MP ref: M1622-RAL-2
DA ref: RAL24/0041
QA: ms.gm.mc

Re: Response to Information Request
Development Application seeking a Development Permit for Reconfiguring a Lot – Subdivision (One Lot into 193 Lots, and Pump Station, Park, and Balance Lot) on land described as Lot 1001 on SP345441 and located at 683 North Shore Boulevard, Mount Low

Information Request

**RE: MOUNT LOW DEVELOPMENTS – 683 NORTH SHORE BOULEVARD (RAL24/0041)
RESPONSE TO INFORMATION REQUEST ITEMS 1, 2 AND 3**

Fig 1 – MIKE 1% AEP WSL Results

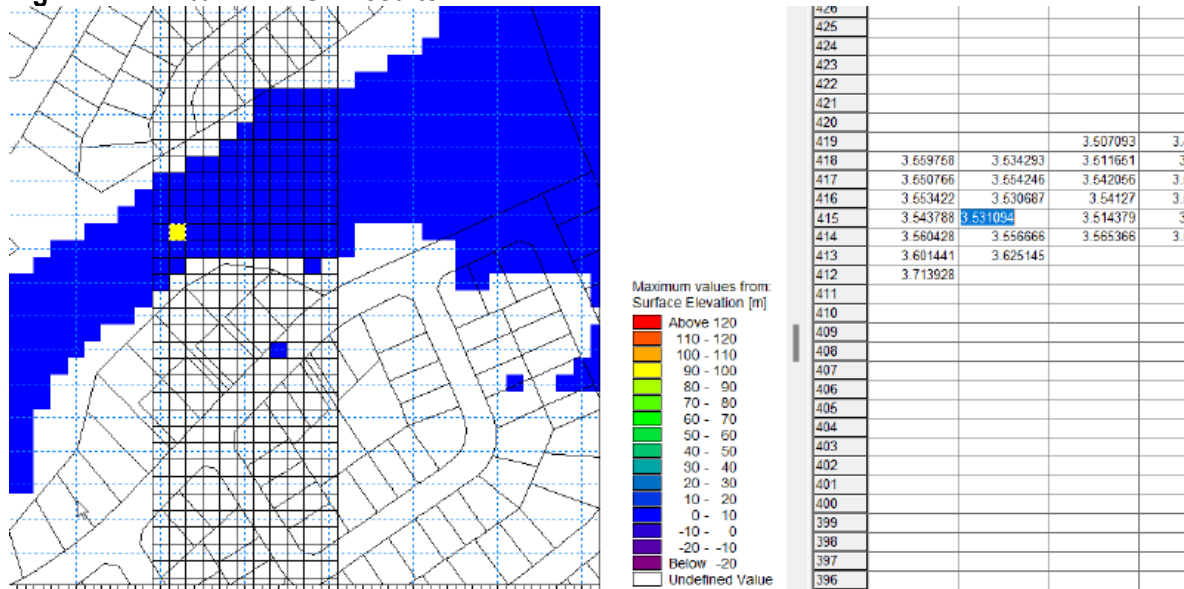
4. Verify 1% AEP flood model result with the available data.
5. Include sewerage pump station in the assessment.

4. The model utilised was the current adopted Council model with a verification carried out showing the results were as expected. As an additional check, the below screenshots show the MIKE baseline model results compared to the same location in TownsvilleMAPS Flood Query Results. The MIKE results show a 1% AEP flood level of 3.531m and the TownsvilleMAPS results show 3.53m.

Figure 4.4: North Shore Boulevard / Road 1 | Priority Controlled Layout

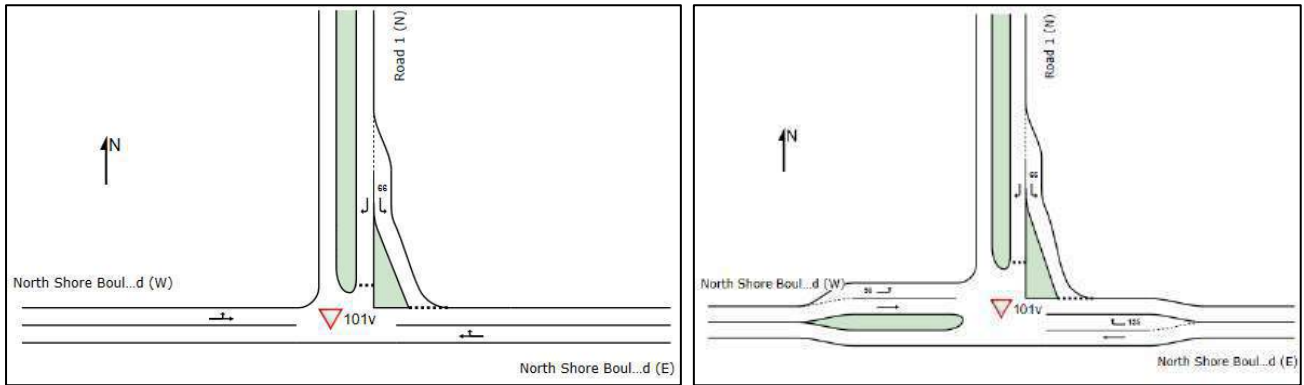
2. Section 4.4.4 of TIA report mentions that turn warrant assessment for a BAL/BAR and AUL/CHR has been conducted for North Shore Boulevard/Road1 intersection but has not been provided. Turn Warrant Assessment Report supporting BAL/BAR is required for North Shore Boulevard/Road 1 intersection (Refer to Austroads GRD4A Section 5, Austroads GTM 06 Section 3.3.5).

As shown, the North Shore Boulevard / Road 1 intersection is expected to operate well within acceptable performance limits ($DOS < 0.9$) under the BAL / BAR configuration at the expected year of opening in 2027 with the proposed 193 lots. As expected, it also operates satisfactorily under the AUL / CHR configuration which is a suitable alternative option. Preliminary investigation showed the AUL / CHR configuration is capable of servicing the full northern development (928 lots) as per Figure 3.2. However, further investigation would be required. Lastly, the intersection operates satisfactorily as a 4-way signalised intersection (ultimate).
